**ADDENDUM 01**

Addendum #	01	Date Issued	03/21/2025
Project Name Job #	SWN 0509, Waneta Hall Renovate Restrooms	OSE #	R0325--15X
		EAPC #	20256780
Bid Date Time	April 3, 2025		3:30pm

PROJECT DESCRIPTION
SWN 0509, WANETA HALL RENOVATE RESTROOMS (OSE# R0325--15X)

DRAWING TITLE
OVERALL PLANS

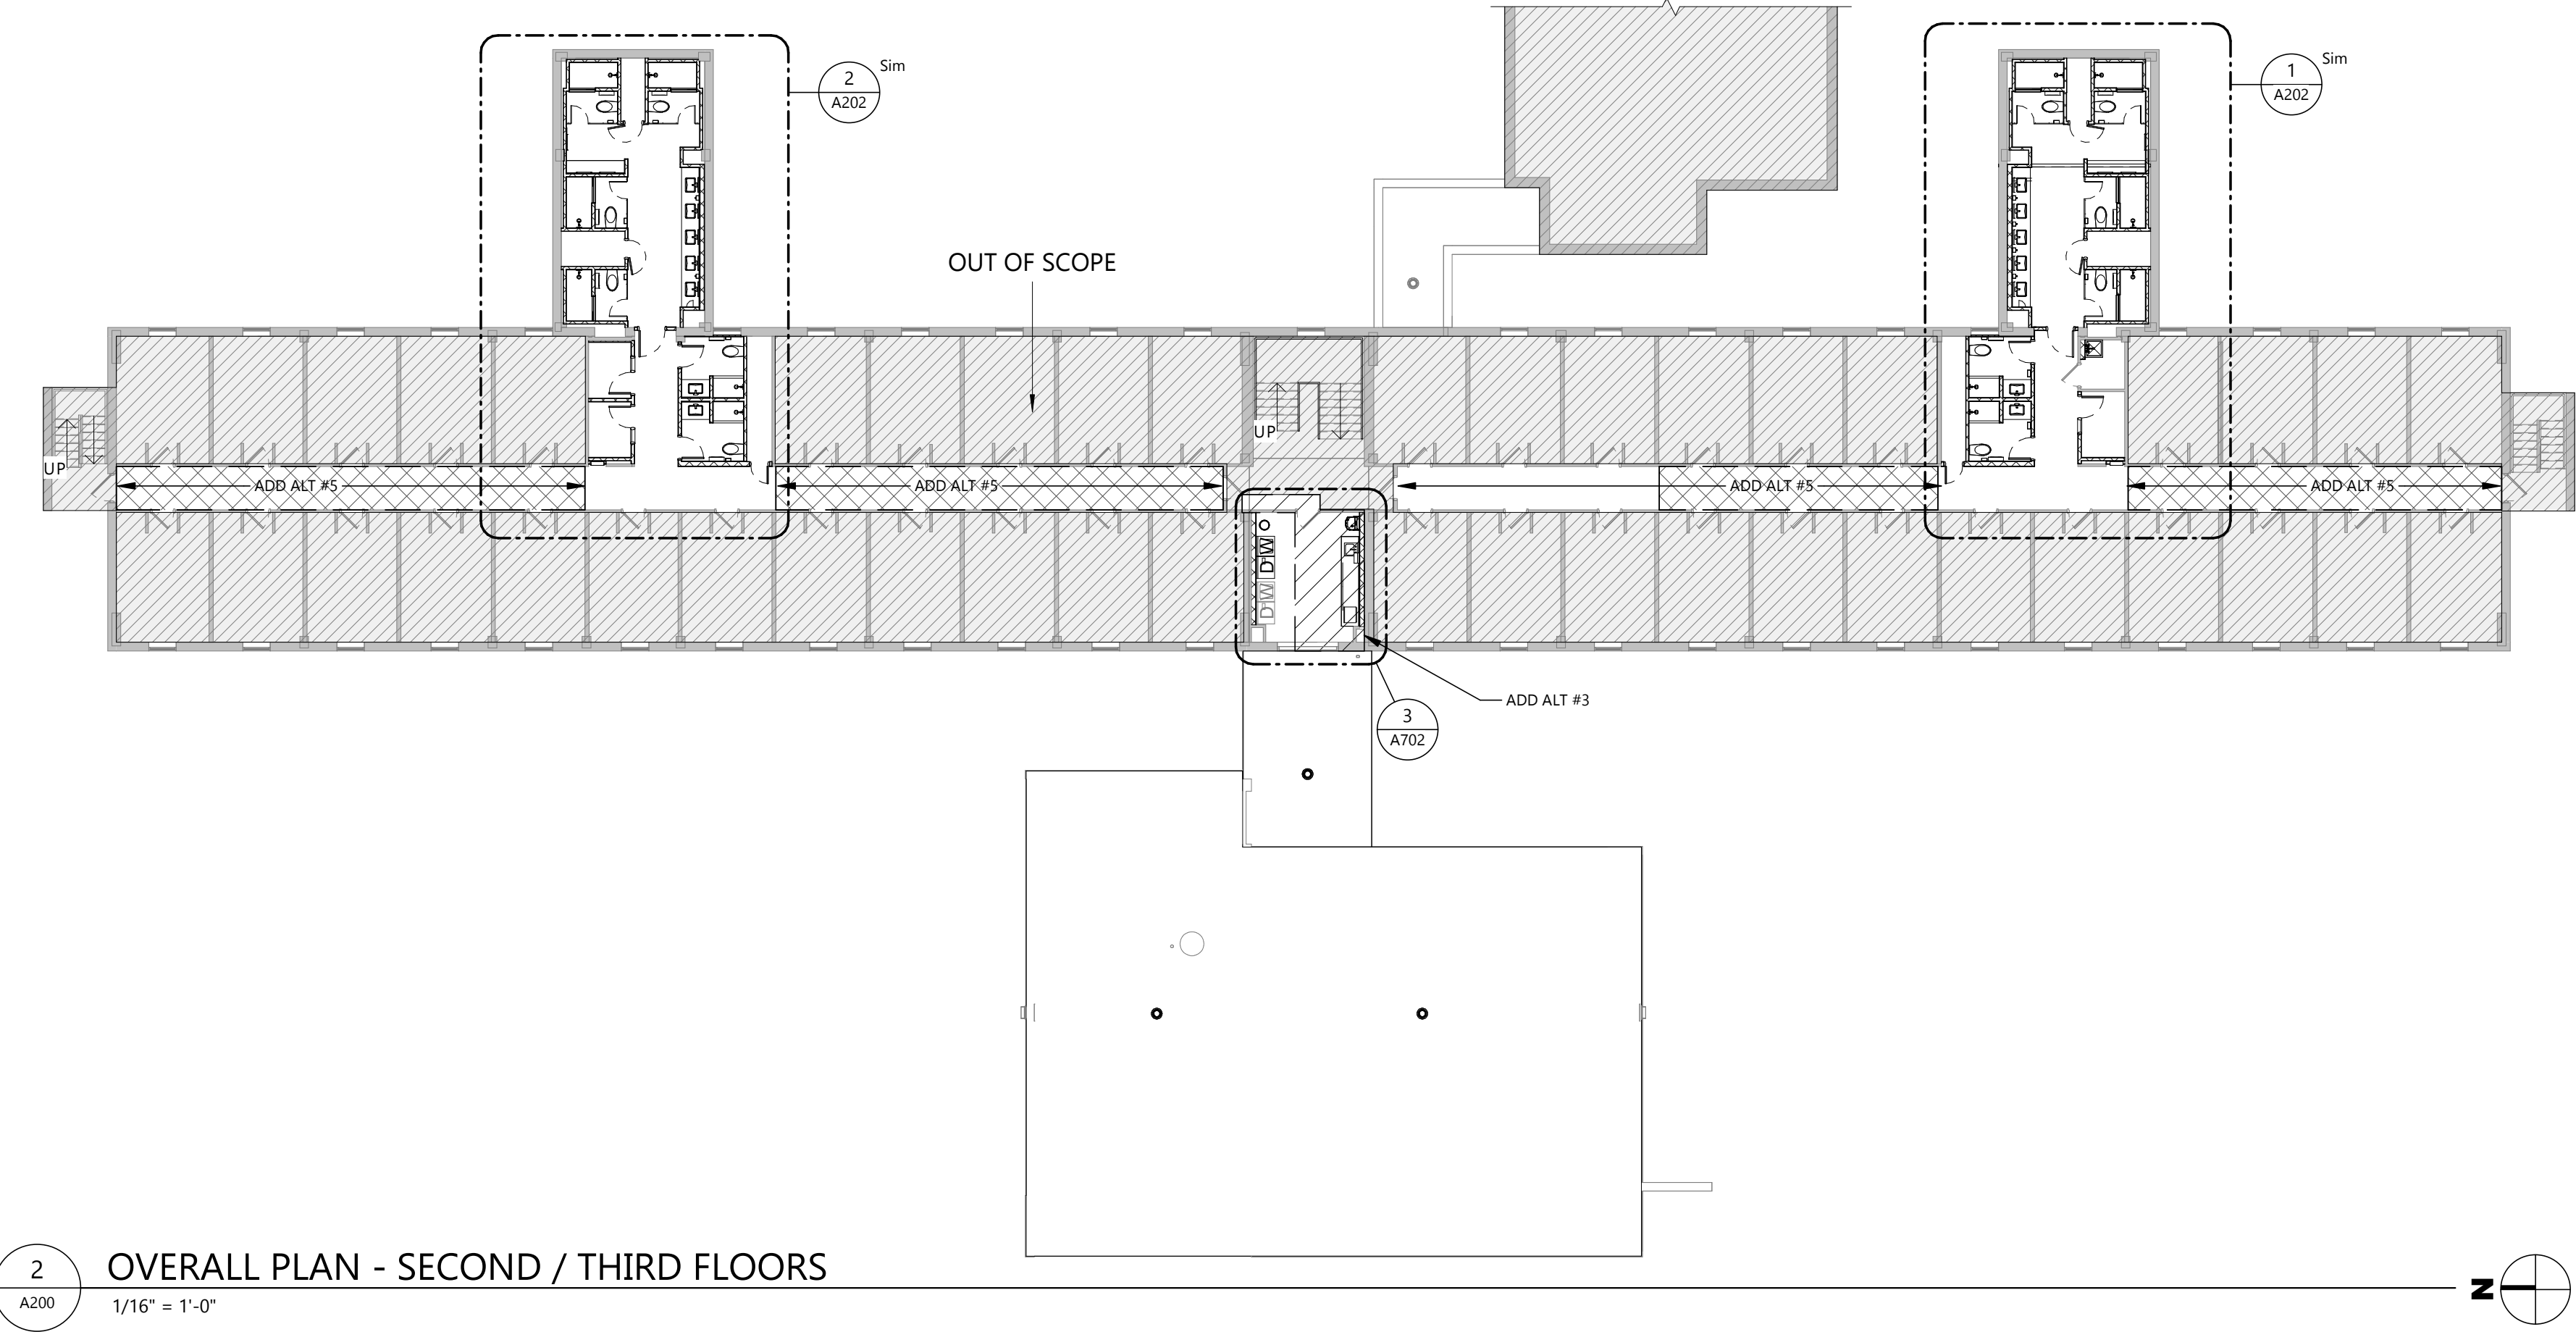
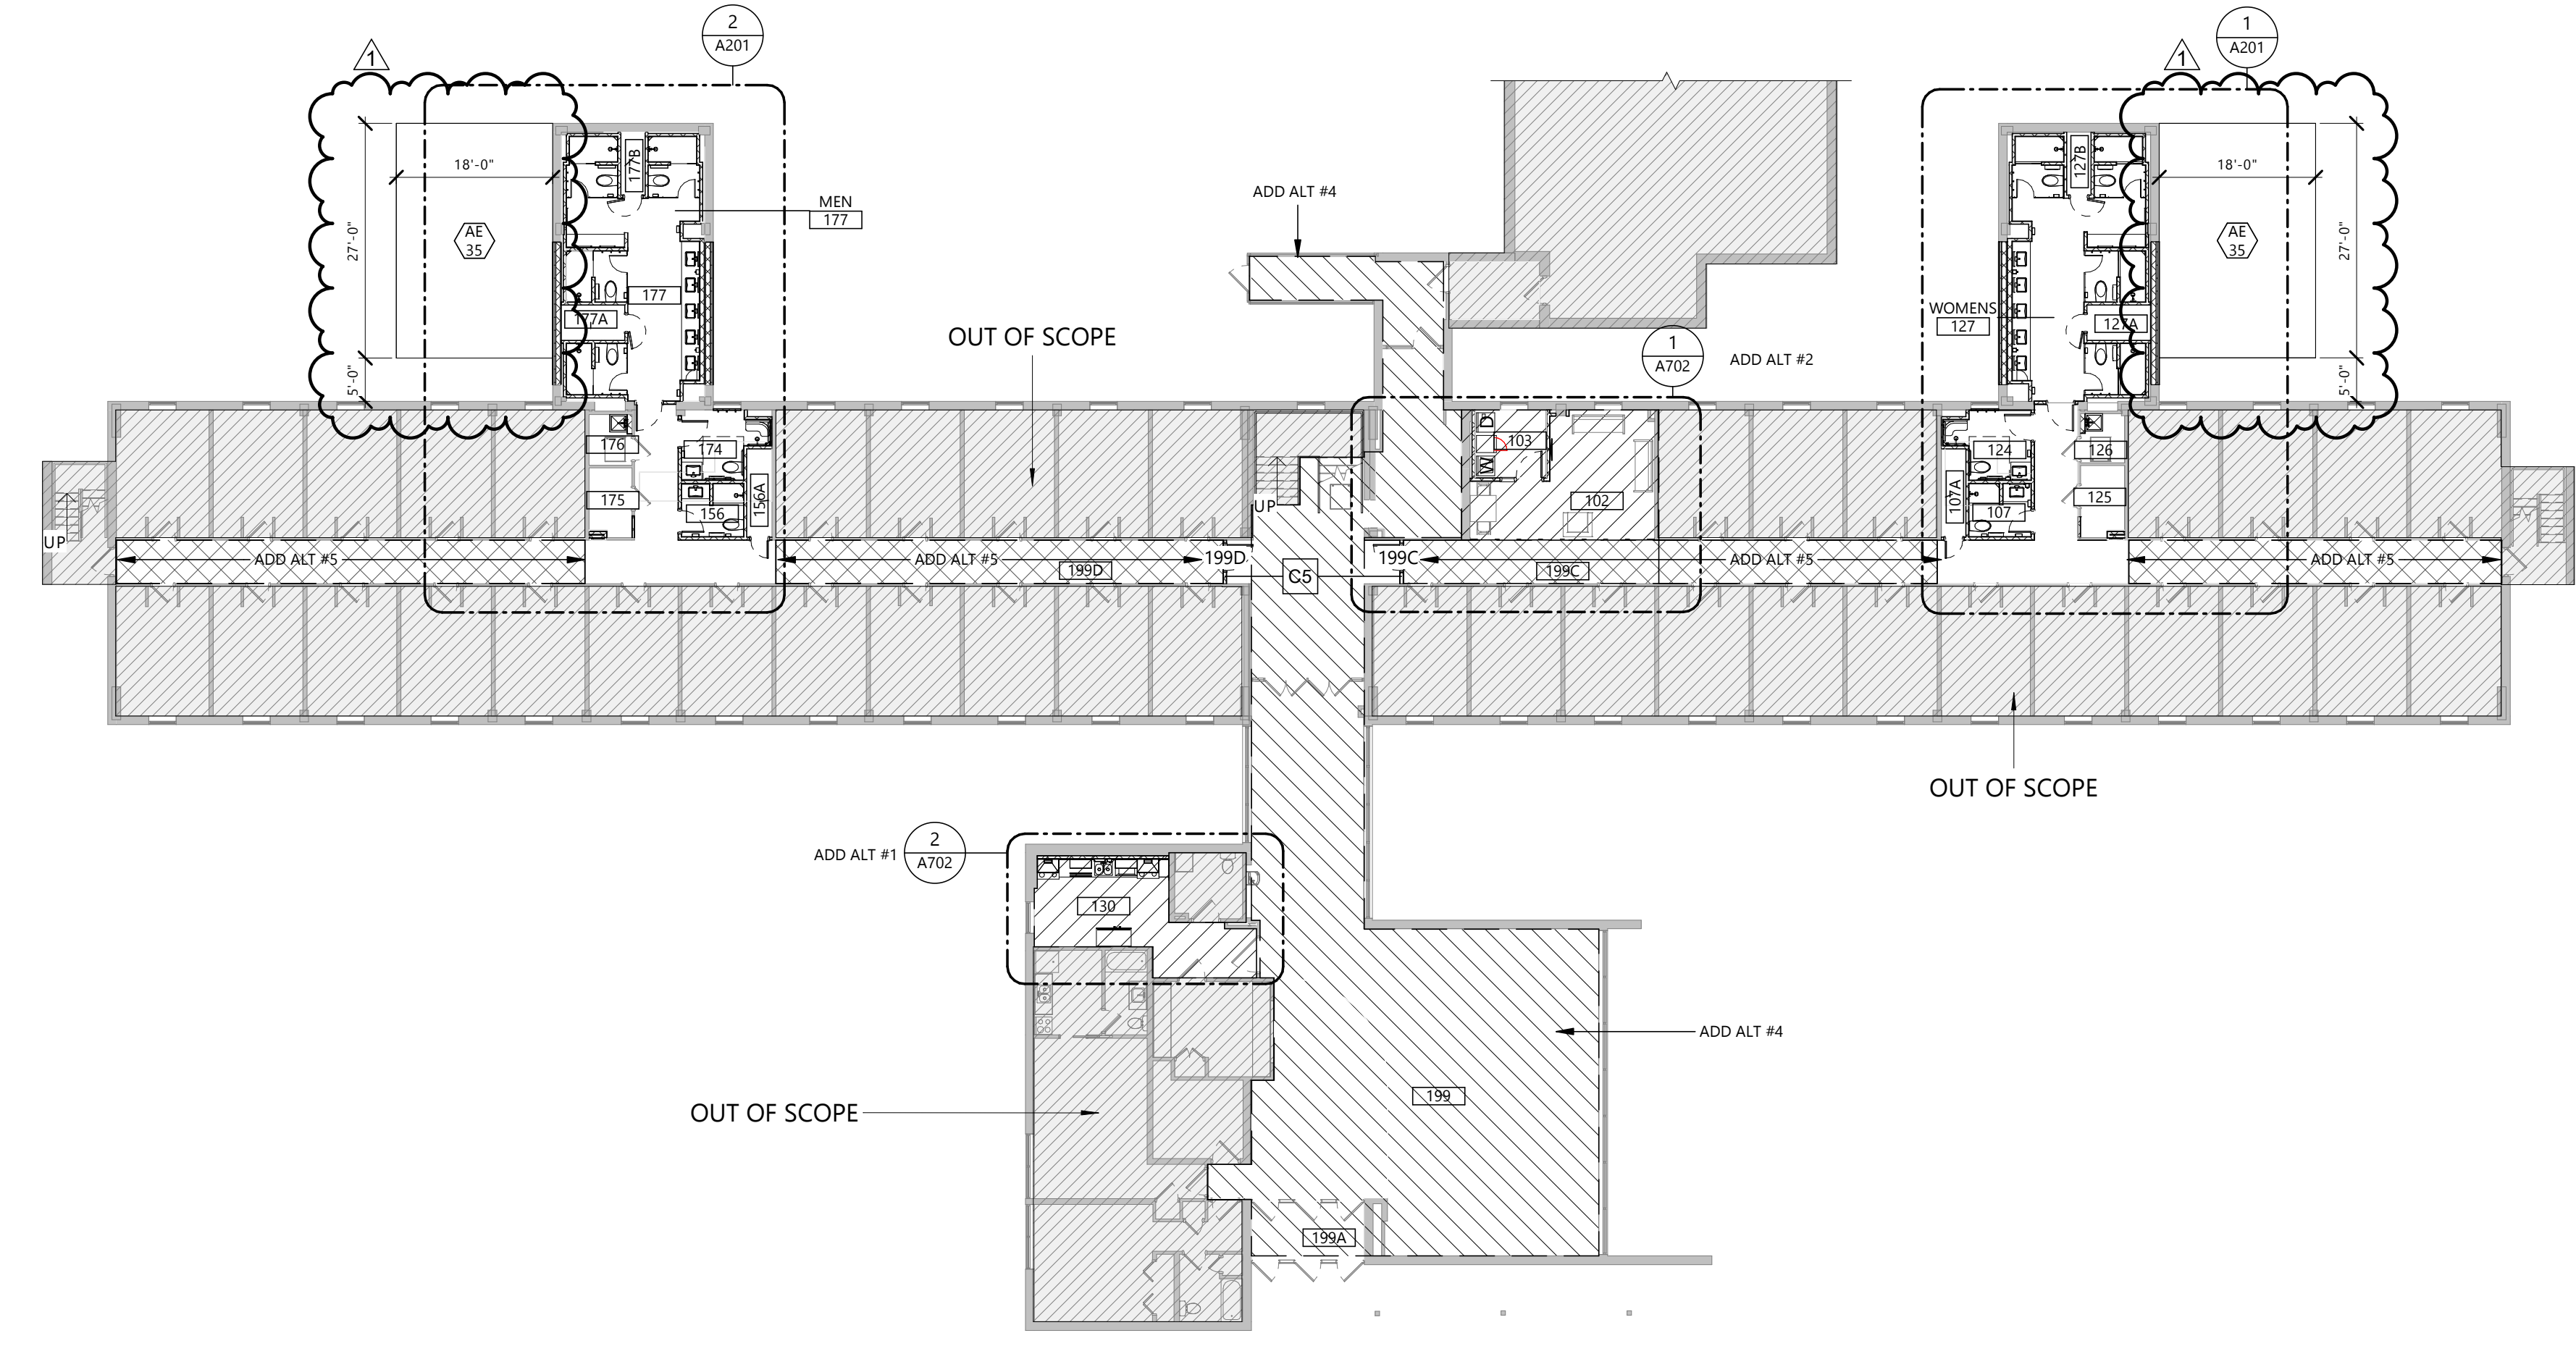
A101	REVISE extents of concrete demolition. REVISE Keynote AD 10.
A200	ADD Keynote AE 35.
A201	REVISE extents of concrete pad. REVISE Keynotes AE 35 & AE 52.
A301	REVISE Issue Date. REVISE General Ceiling Note #6. ADD Keynotes AE 02 and AE 03. Revise ceiling and lighting layouts in rooms 125, 175 and the hallways around the new construction.
A302	REVISE General Ceiling Note #6. ADD Keynote AE 03. Revise lighting layouts in the hallways around the new construction. ADD notes for extents of Alt. #5 on 1/A302.
A303	REVISE General Ceiling Note #6. ADD Keynote AE 03. Revise lighting layouts in the hallways around the new construction.
A304	REVISE issue date. REVISE lighting layout on at the student space 102. Extend wall in Kitchen 130 to ceiling.

- <<< INDICATES KEYNOTE ON PLAN
- AE 35 CONCRETE ERU PAD TO BE PROVIDED BY G.C. 8" SLAB WITH #4 REBAR AT 12" OC EACH WAY AND THICKENED SLAB EDGES AT 14" DEEP BY 24" WIDE. PROVIDE 12" GRANULAR FILL, COMPACTED TO A MINIMUM OF 95% OF STANDARD PROTOR, BELOW SLAB. SLOPE CONCRETE AT 1/8" PER 12" AS INDICATED ON PLAN. SEE OVERALL PLAN ON A200 FOR DIMENSIONS TO BE INCLUDED ON BOTH WINGS OF THE BUILDING.
